Ok for V2b

(c) 2014 Golden Delicious Computers GmbH&Co. KG. Licensed under CC-BY-SA.

Buttons

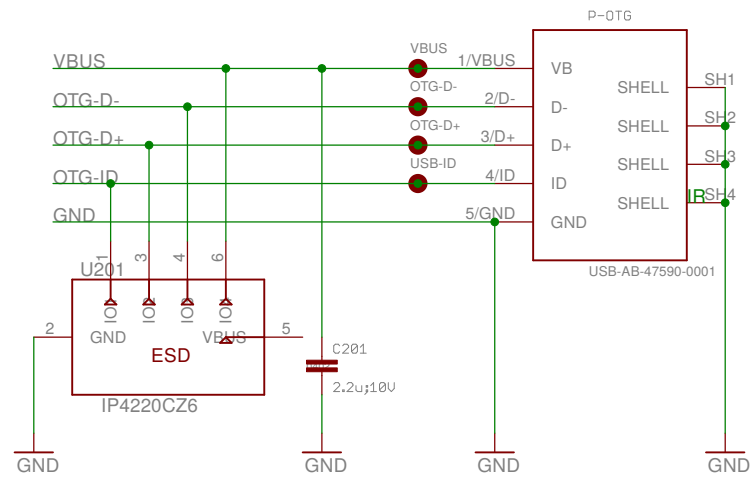
place in scan matrix? would need 3-4 wires to UPPER board instead of 2!
 No. VOL+ or VOL- can either be connected to GPIOs
 or drive two FETs that sit in the keyboard matrix
 in any case it is sufficient to connect GPIO-VOL+ and VOL- to two pins on the B2B connector

OTG

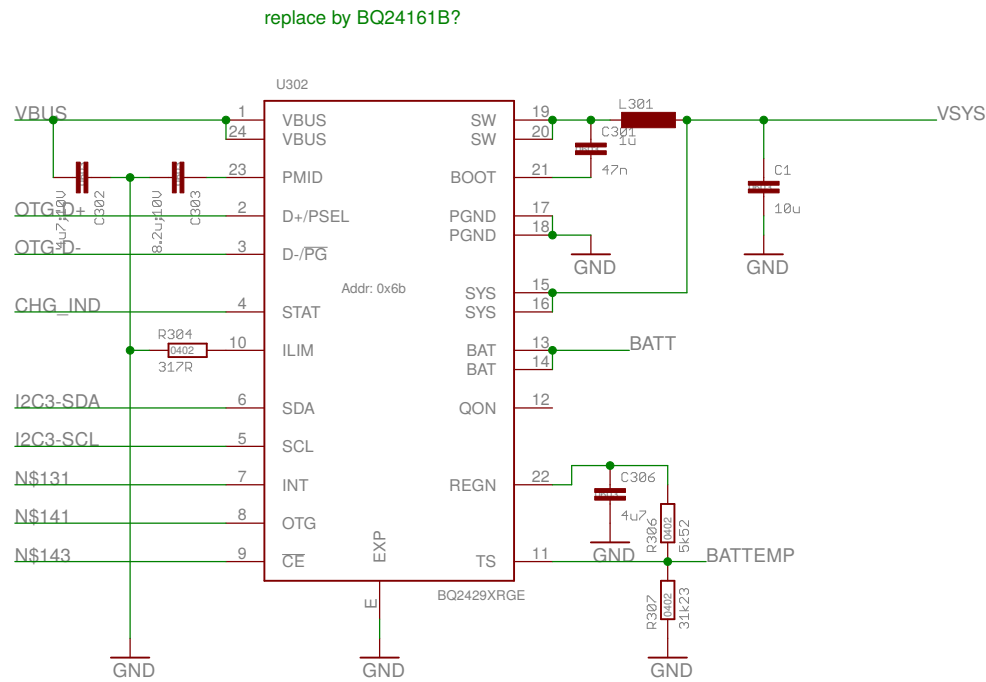
Layout: place test points in battery bay

Sensors

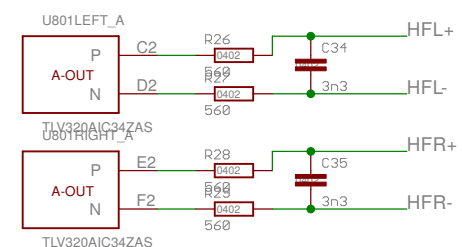
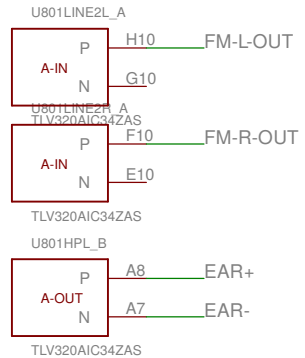
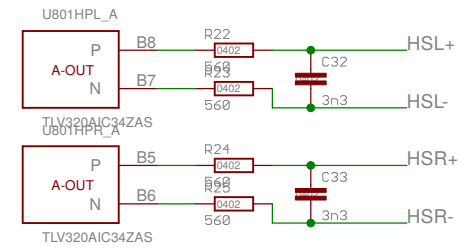
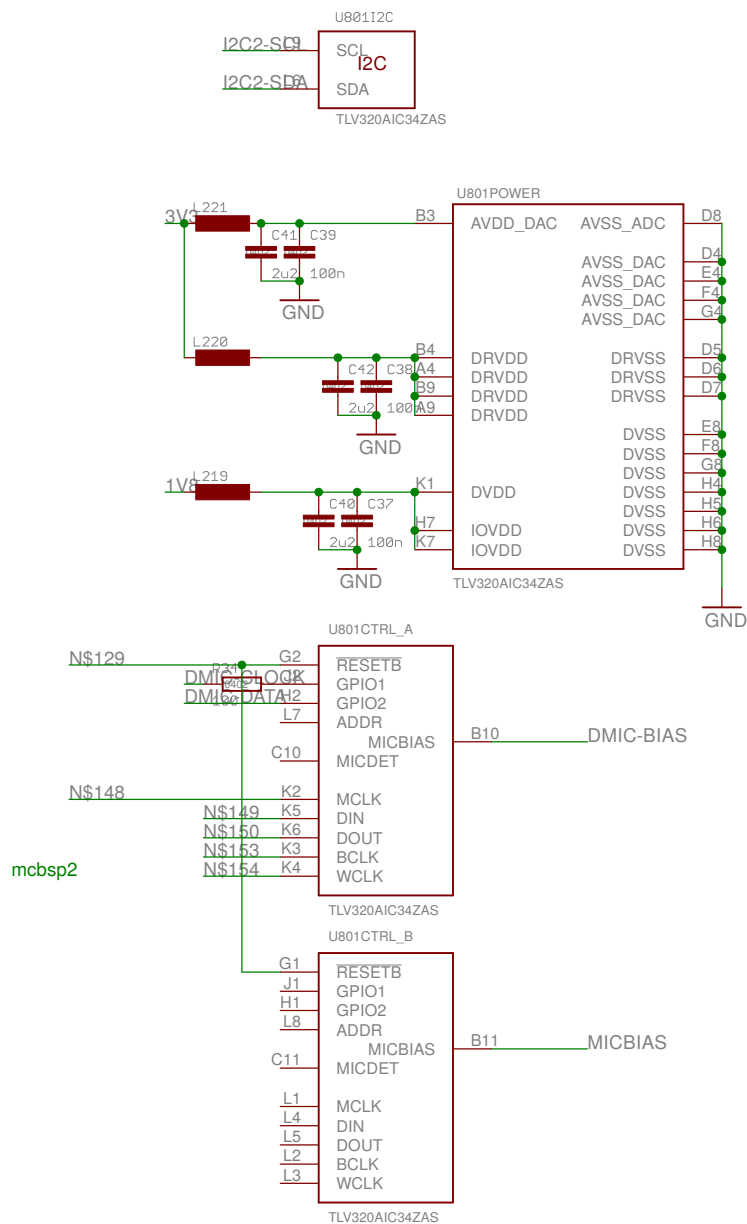
conflict with bmc150?

address: 0x18-0x1b

Audio Codec

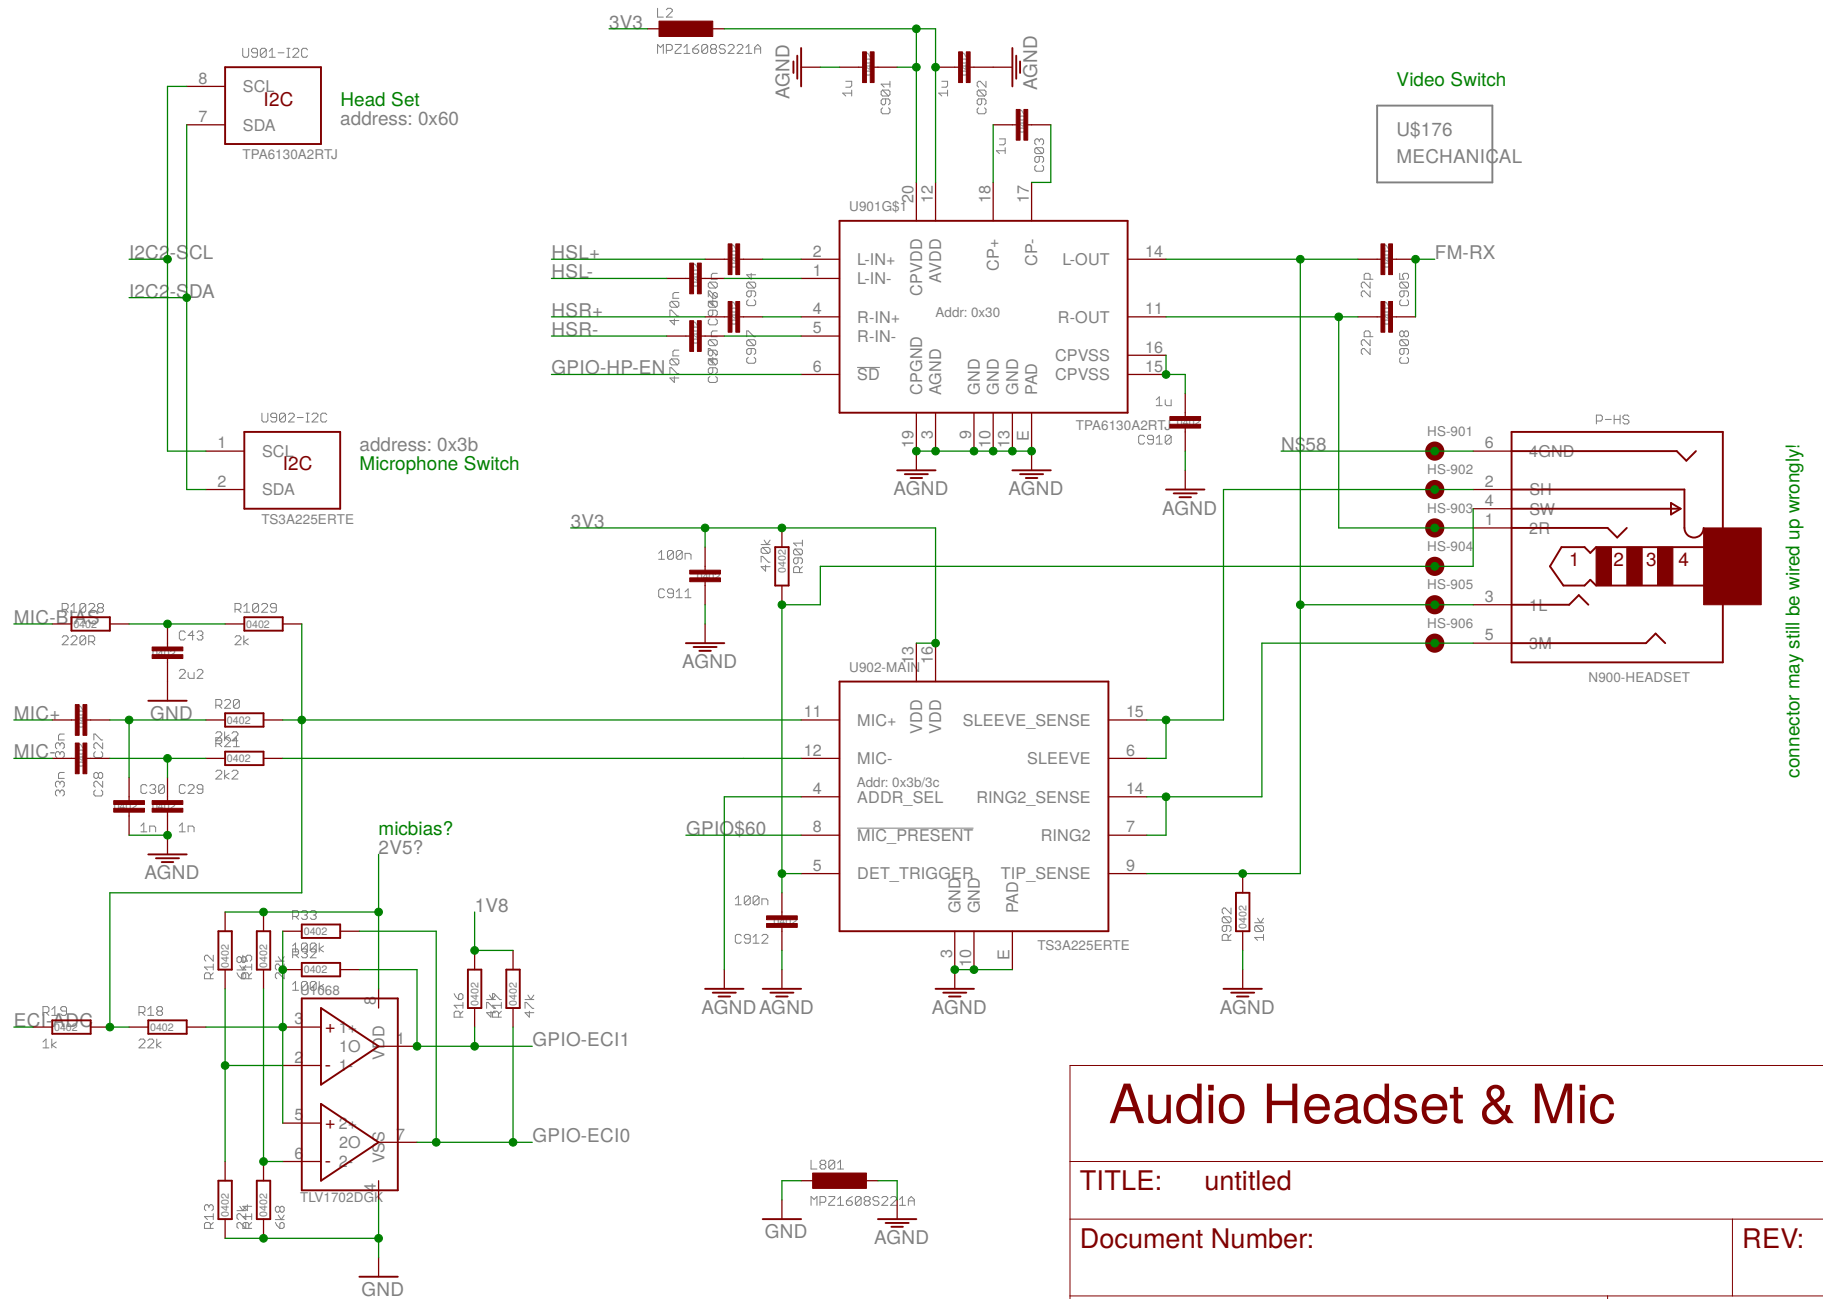
problem: this is a 0.5mm BGA making lower board expensive!
but it appears to be not extremely critical (only 3 rows and inner ring is GND)
problem: analog mic is on upper board!
alternative: place on upper board (to be evaluated)

GPS

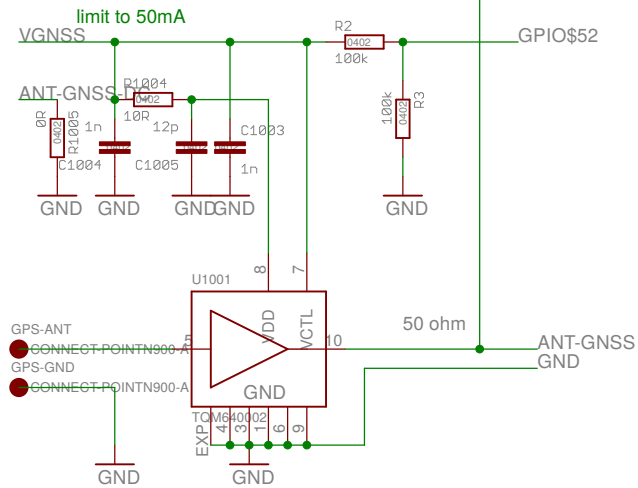
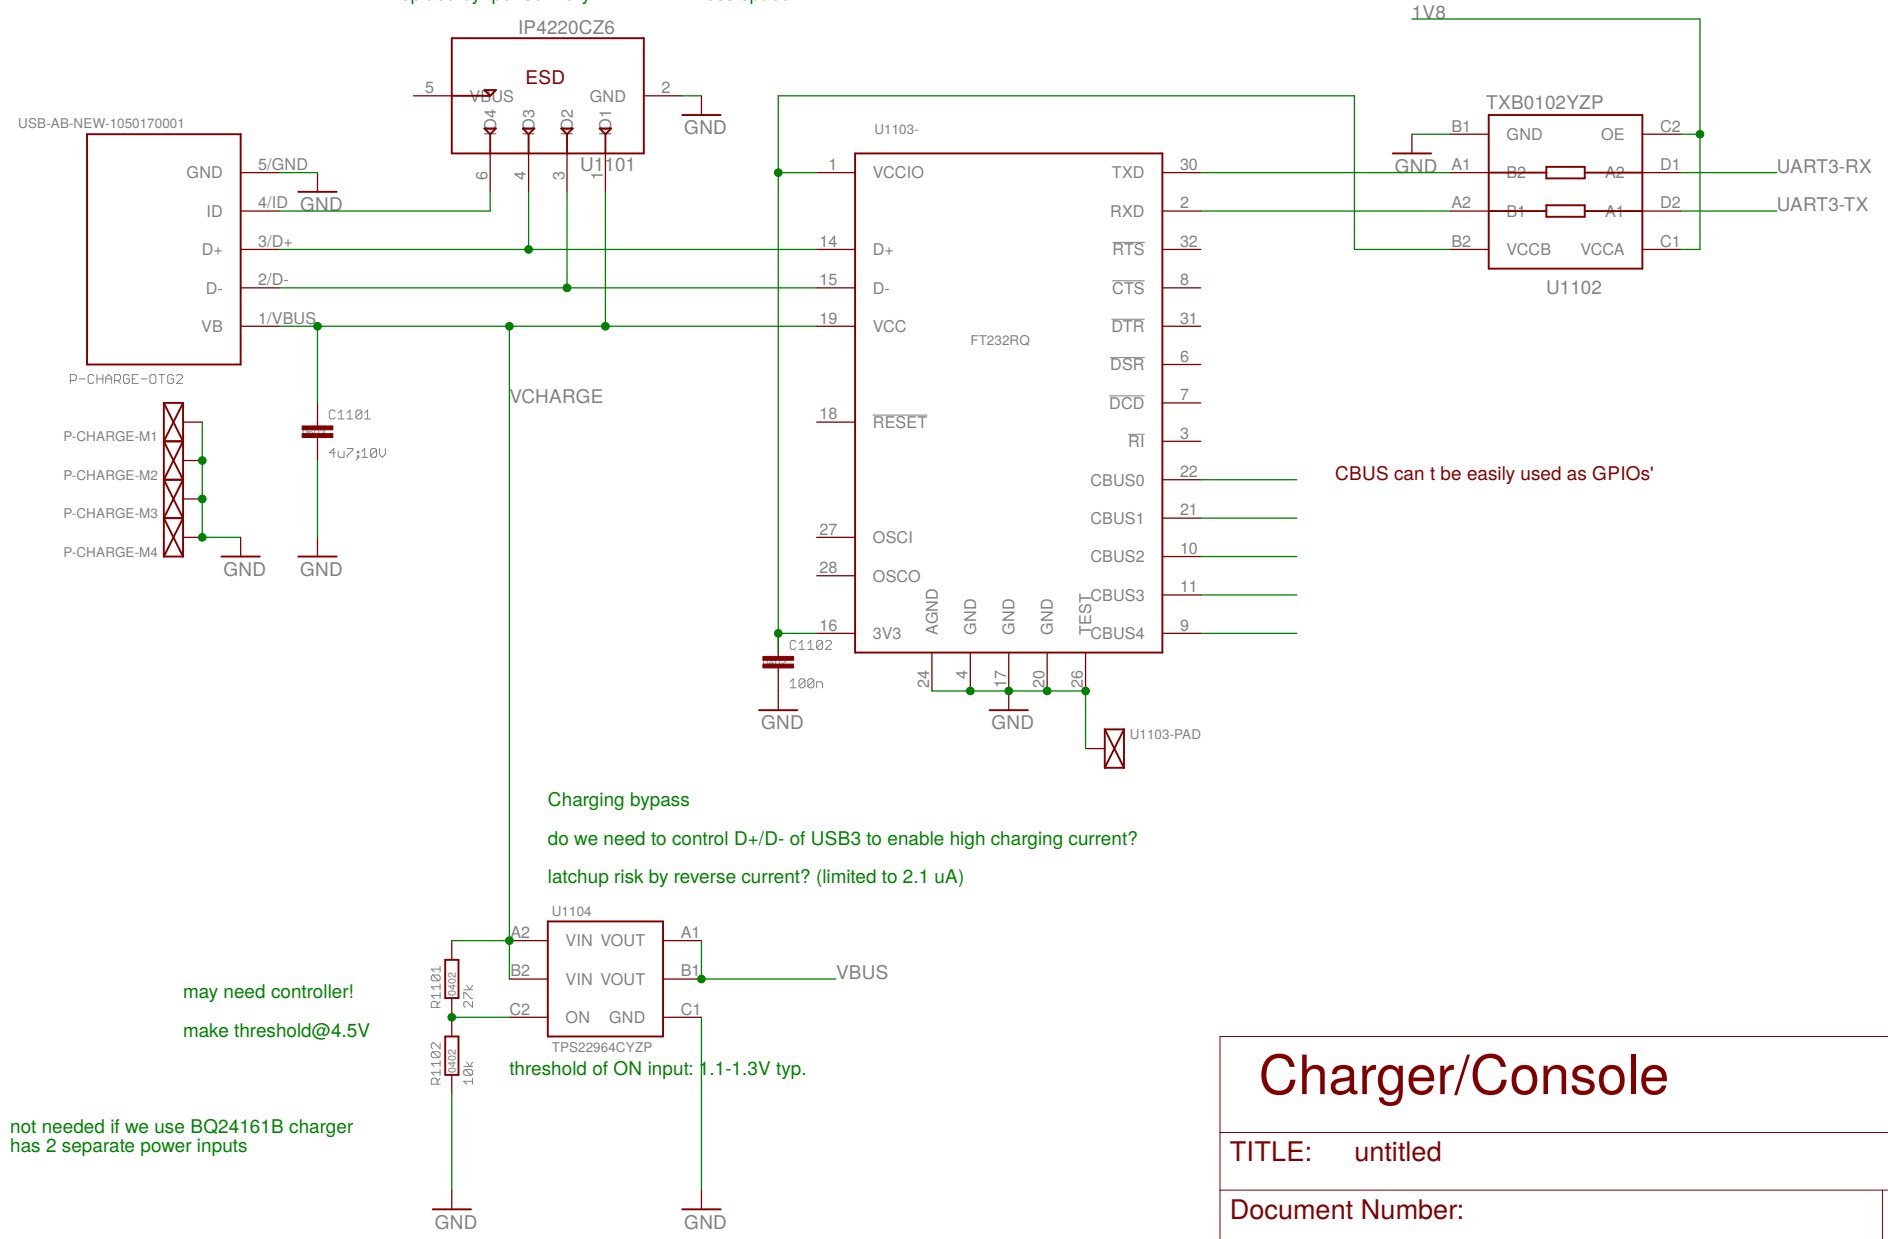
not needed if we can interrupt the ANT

separate supply?
independent of Modem?

Charger/Console

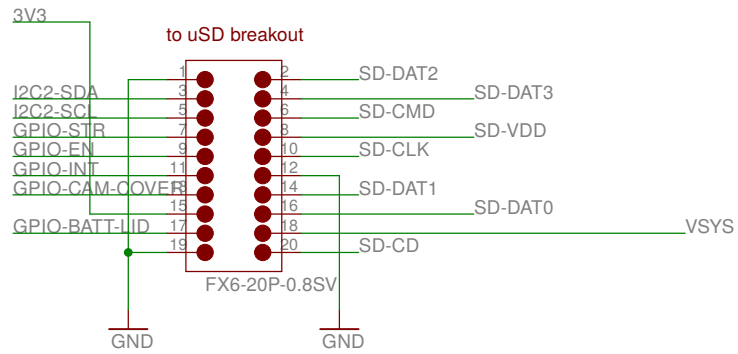
replace by tpd4s012dryr? less space?

Misc (lower)

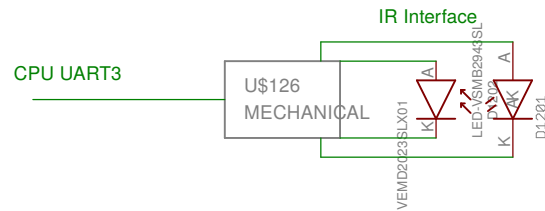
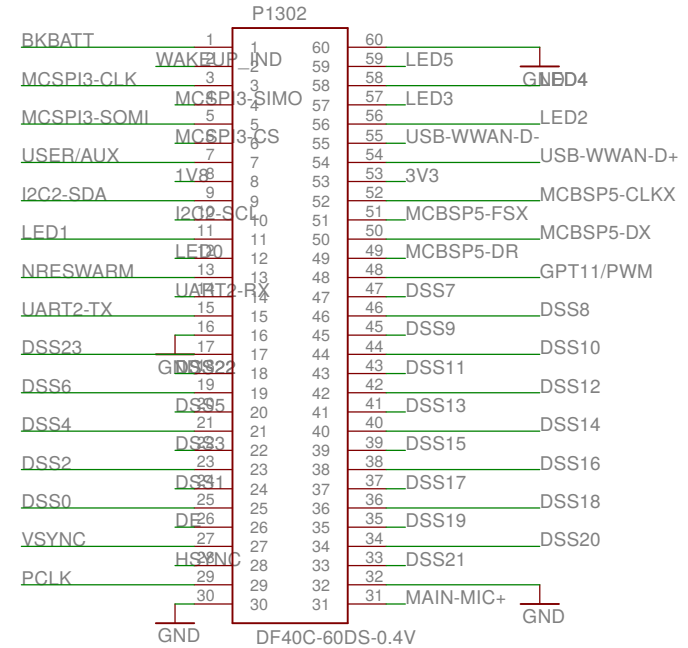
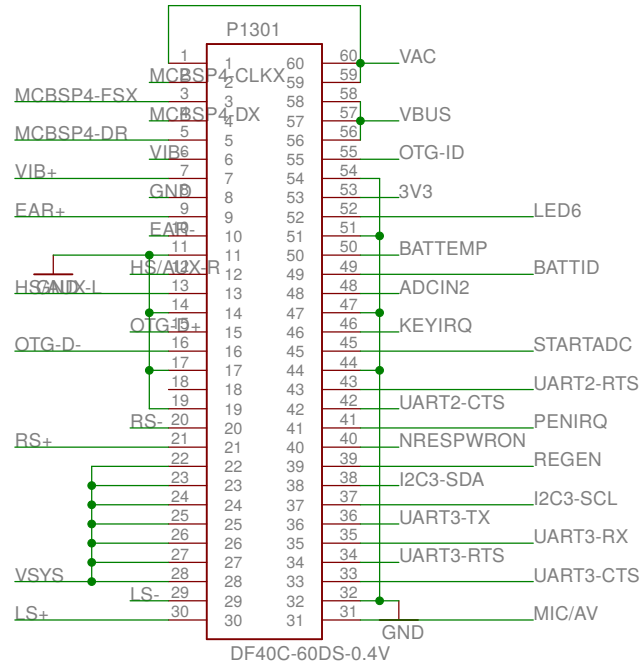
2nd microphone on lower board? Or on bottom of upper?
